MPC Paper No. A/K14/766  
For Consideration by  
the Metro Planning Committee  
on 31.5.2019

**APPLICATION NO. A/K14/766**

- Application** : Proposed Minor Relaxation of PR and BH Restrictions for Permitted Office, Shop and Services & Eating Place Uses

繪圖  
**DRAWING**  
**A - 13**

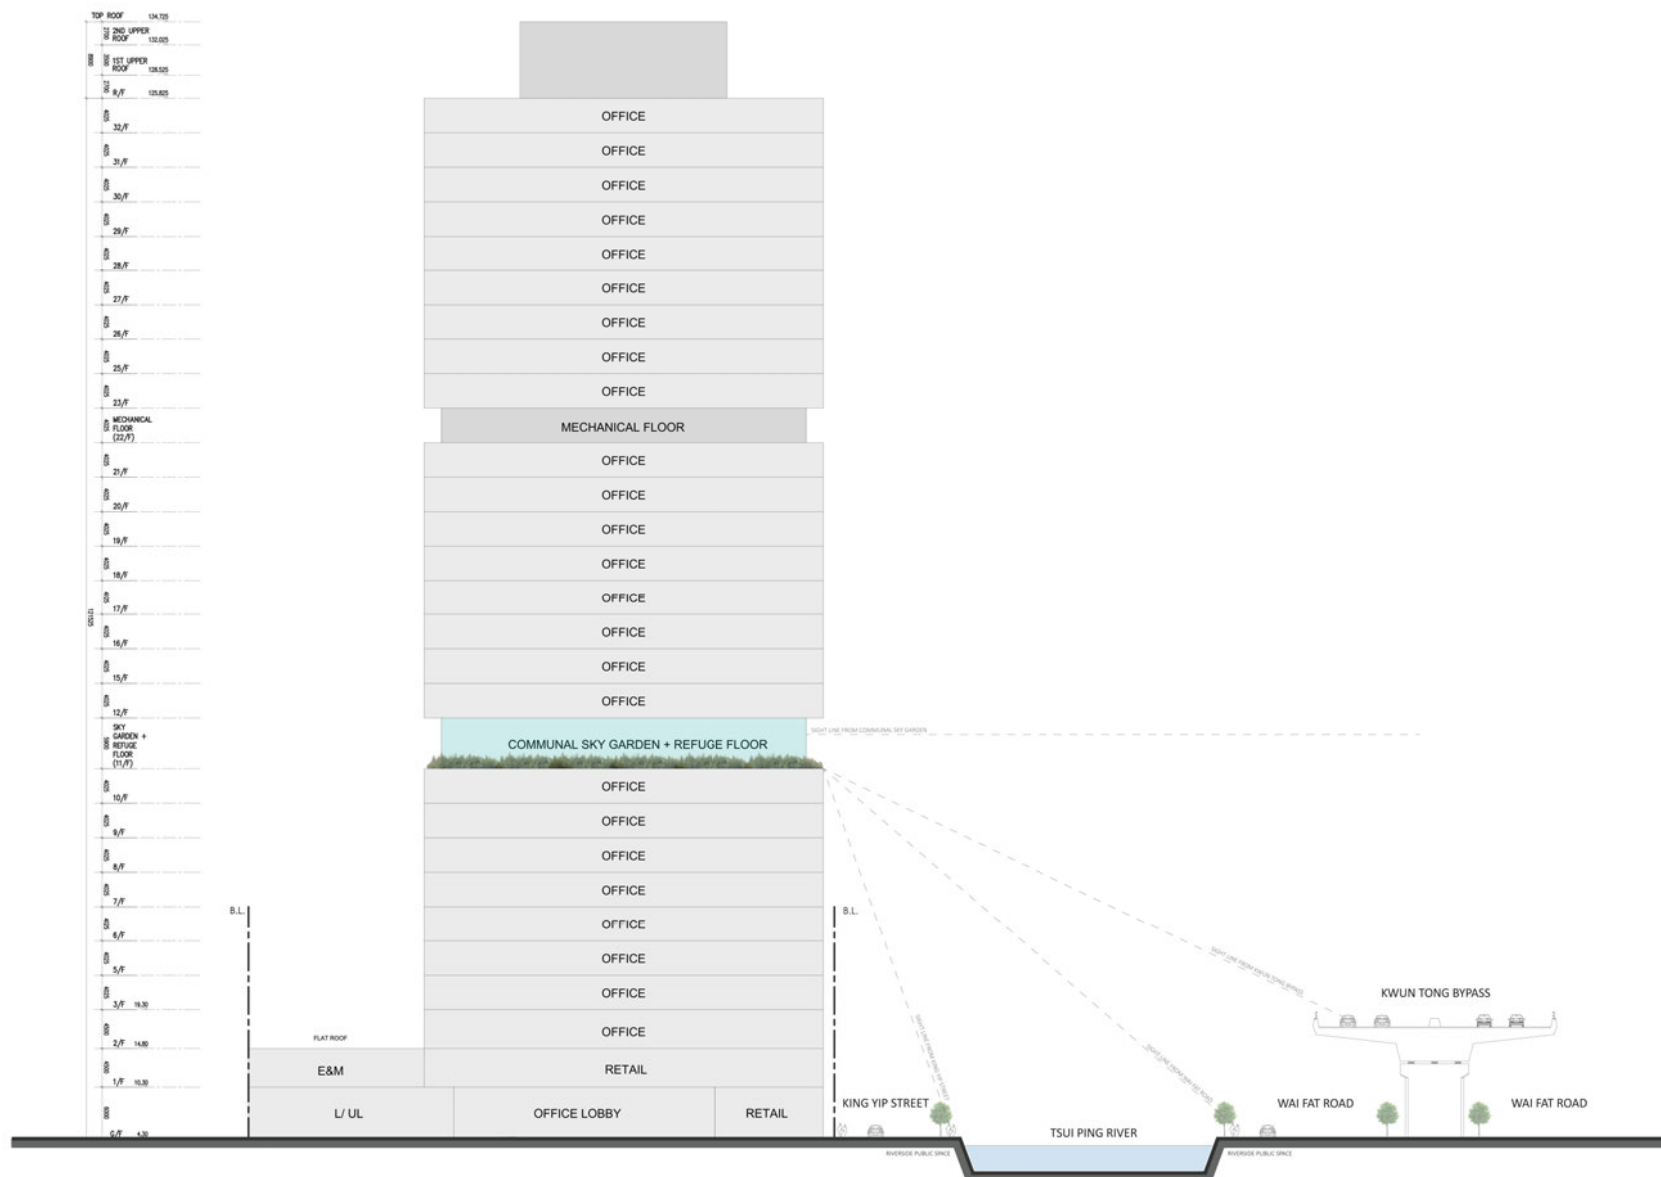
- (b) On urban design aspect, as illustrated in the sectional drawing (**Drawing A-13**), the proposed setback along King Yip Street facing Tsui Ping River will improve the pedestrian environment and create a pedestrian scale at street level. Also, some landscape features have been provided at the low zone, such as vertical greening at G/F of the southwestern façade, and some greenery at 2/F of the southeastern façade.
